Metropolitan Historic Zoning Commission  
Sunnyside in Sevier Park  
3000 Granny White Pike  
Nashville, Tennessee 37204  
Telephone: (615) 862-7970  
Fax: (615) 862-7974

## STAFF RECOMMENDATION 1926 Twentieth Avenue South April 19, 2017

**Application:** New construction-outbuilding/detached accessory dwelling unit; Setback determination

**District:** Belmont-Hillsboro Neighborhood Conservation Zoning Overlay

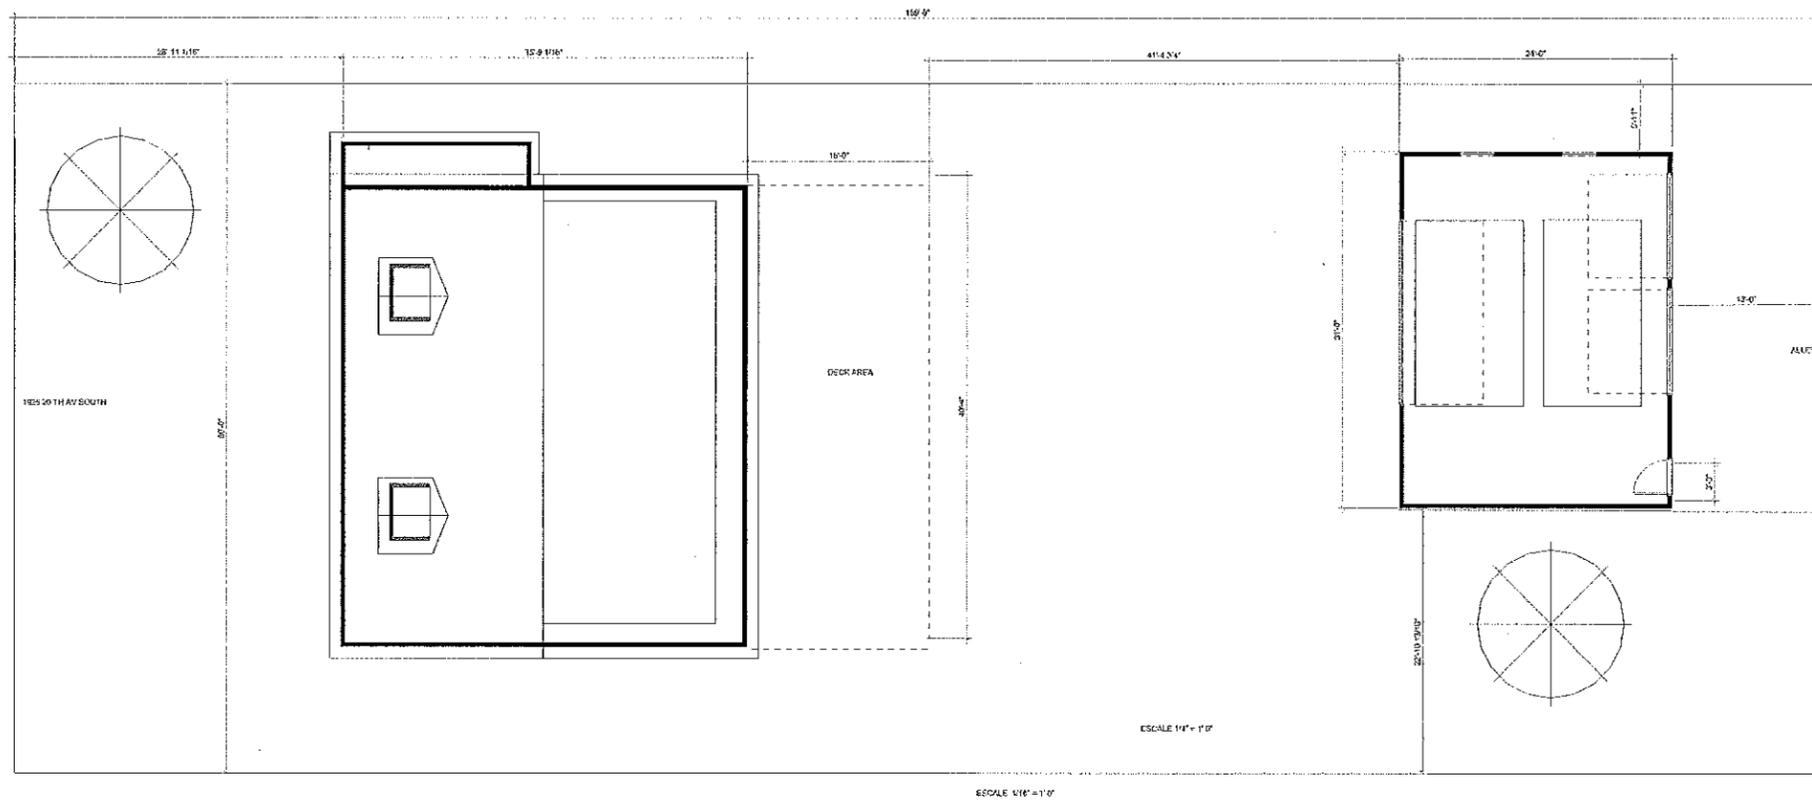
The plans show a DADU with an overall height and average eave height taller than the maximum permitted. However, the applicant has indicated on the plans that he is willing to reduce the height of the concrete slab foundation from two feet (2') to approximately three inches (3"), which will make the overall height a maximum of twenty-five feet (25') and reduce the average eave height to approximately eight feet, nine inches (8'-9"). Staff recommends including conditions that the maximum overall height, as measured from grade, not exceed twenty-five feet (25') and that the maximum average eave height, also as measured from grade, not exceed ten feet (10'). Also, plans showing this shall be submitted prior to issuance of a preservation permit. With these conditions, staff finds that the proposed DADU can meet Section II.B.i.1. of the design guidelines and 17.16.30.G. 7 of the ordinance.

1. Staff receive a copy of the filed restrictive covenant for the detached accessory dwelling unit prior to issuance of a permit;
2. The site plan shall show the driveway prior to issuance of the preservation permit;
3. The maximum height of the DADU shall not exceed twenty-five feet (25') as measured from grade;
4. The maximum average eave height shall not exceed ten feet (10') as measured from grade;
5. Staff approve the materials for the roof color, windows, doors, garage door, trim, and driveway material prior to purchase and installation;
6. Siding and trim shall be smooth-faced, and siding shall have a maximum reveal of five inches (5"); and
7. The HVAC be located either at the sides or rear of the structure.

Scale: 1/16 = 1'

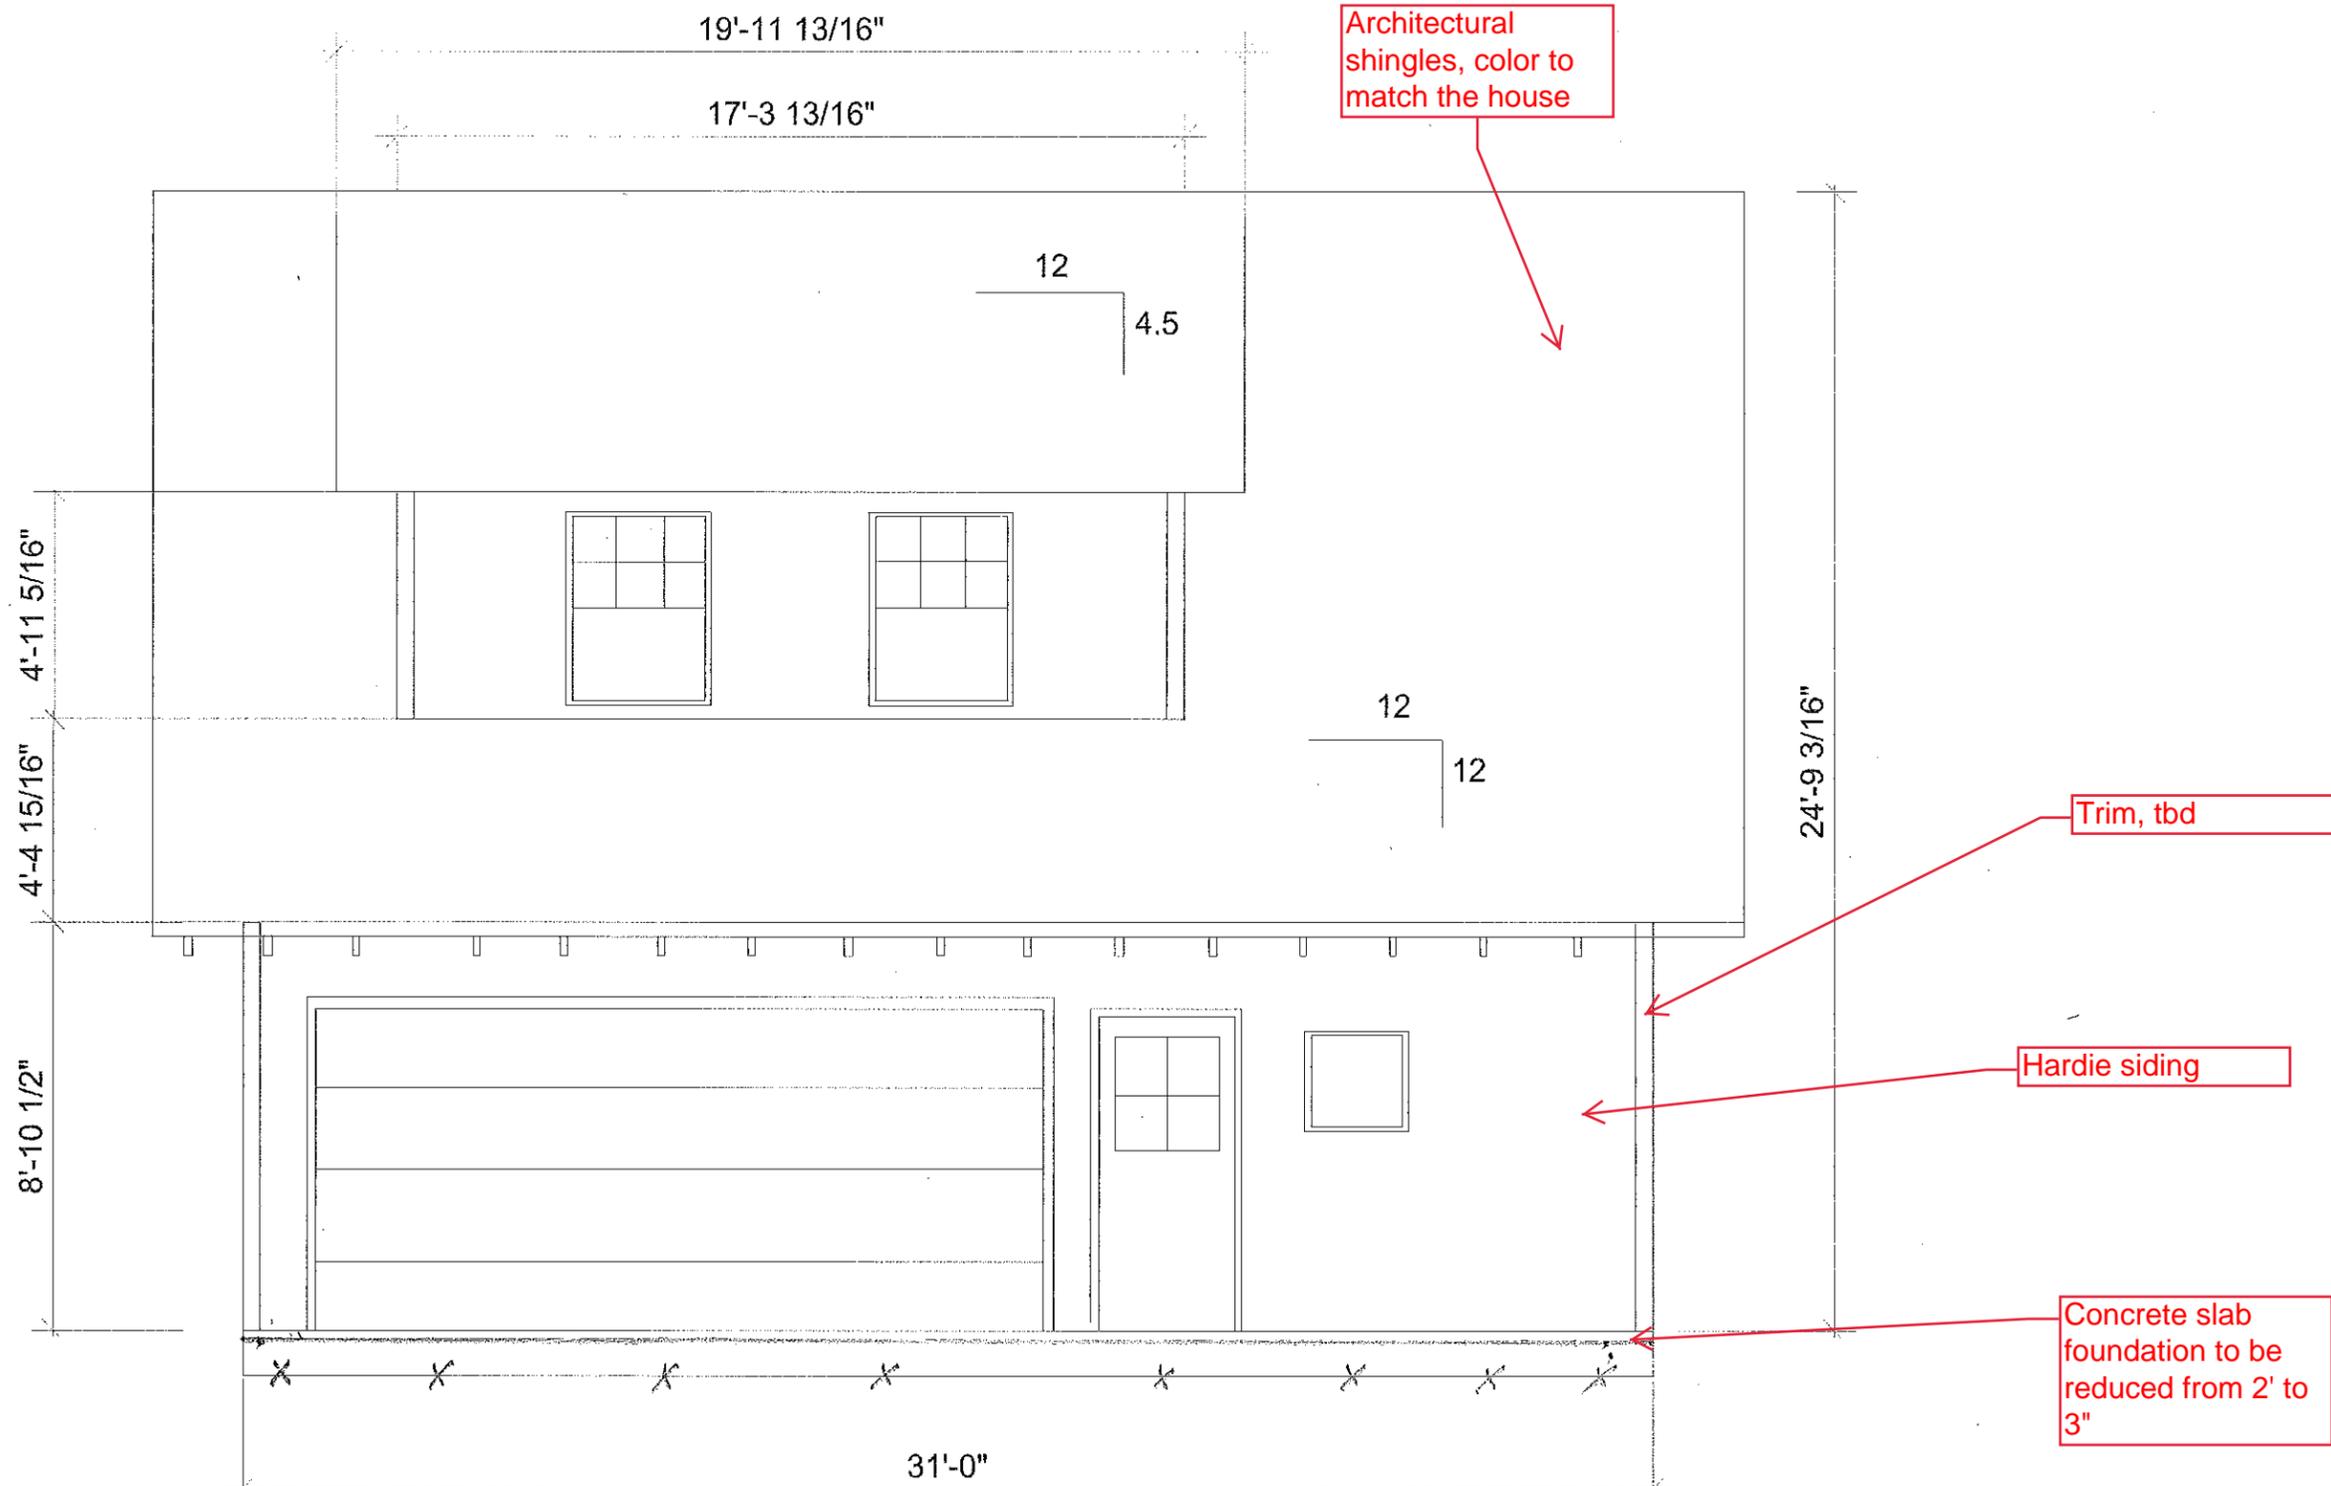
For outbuildings that have footprints that are larger than seven hundred square feet (700 sq. ft.), the base zoning setbacks are five feet (5') for the side and twenty feet (20') from the rear property line. In this case, the proposed DADU meets the side setbacks required by the base zoning but does not meet the required rear setback. The proposed DADU will be thirteen feet (13') from the rear property line, which requires a rear setback determination.

Staff finds that the proposed thirteen foot (13') rear setback to be appropriate because historically, outbuildings were situated close to the rear property lines. A thirteen foot (13') rear setback is more historically appropriate than a twenty foot (20') rear setback. In addition, if the DADU were less than seven hundred square feet (700 sq. ft.), the base zoning rear setback would be just three feet (3'). The reduced rear setback allows for more space in between the house and the outbuilding, which is appropriate. For these reasons, staff recommends approval of the rear setback determination.

With approval of the rear setback determination, staff finds that the project meets Section II.B.i.2 of the design guidelines and 17.16.030.G. 4 of the ordinance.

WEST ELEVATION  
ESCALE 1/4" = 1' 0"

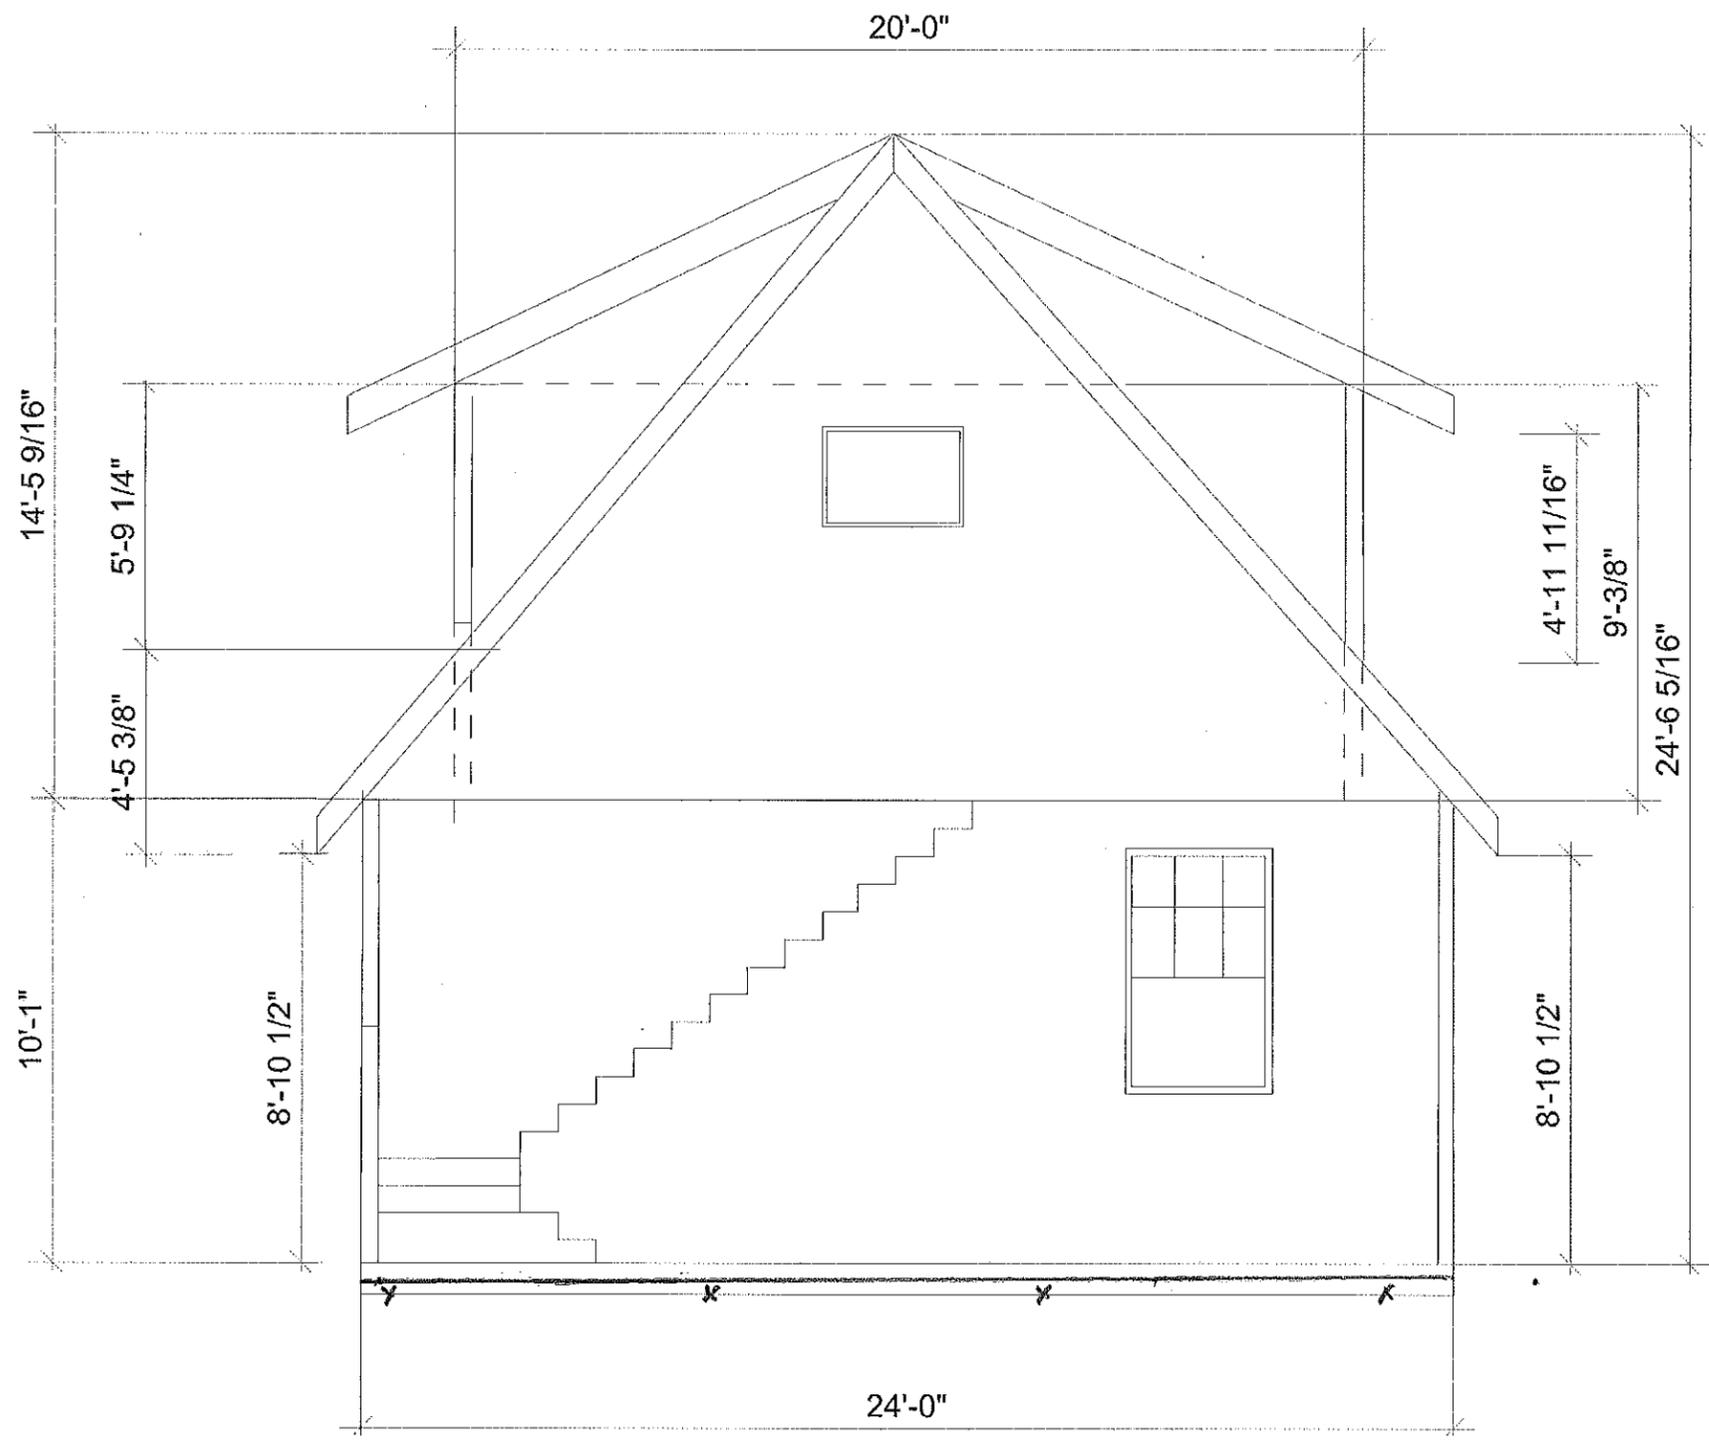
Since it is not noted on the plans, staff recommends a condition that all siding and trim be smooth-faced and that siding have a maximum reveal of five inches (5”) as required by the design guidelines. With this condition and staff’s final approval of the roof color,

Concrete slab foundation to be reduced from 2' to 3"
